PRODUCT/PROCESS CHANGE NOTICE (PCN)

PCN #: A0508-01 DATE: 10/10/2005 Product Affected: Green 28L TSOP (PZG28) package Date Effective: 1/9/2006	MEANS OF DISTINGUISHING CHANGED DEVICES: <input type="checkbox"/> Product Mark <input checked="" type="checkbox"/> Back Mark Encrypted "A" prefix on the assembly lot number. Refer to Attachment 2. <input type="checkbox"/> Date Code <input type="checkbox"/> Other
--	---

PCN Type: Change in assembly location from Chippac/Stat-China to OSE-Taiwan for green 28L TSOP (PZG28) package.

Illustration of the foot length

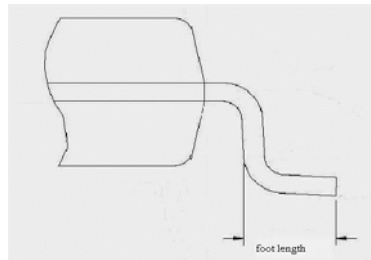
Detail of Change: IDT have completed the qualification to change the assembly location of the green 28L TSOP (PZG28) package from Chippac/Stat-China to OSE-Taiwan. The 28L TSOP from OSE-Taiwan have a slightly shorter foot length. Please refer below for the details. There is no change in the lead tip-to-lead tip length of the package.

There is no change to the existing Moisture Sensitive Level (MSL). There is a change to the Datasheet for the foot length dimension as below :-

Description	From	To
Assembly Location	Chippac/Stat-China	OSE-Taiwan
Foot Length range (min - max)	0.5 - 0.7 mm	0.3 - 0.7 mm

Note : Foot length requirement for JEDEC is 0.5 - 0.7 mm.
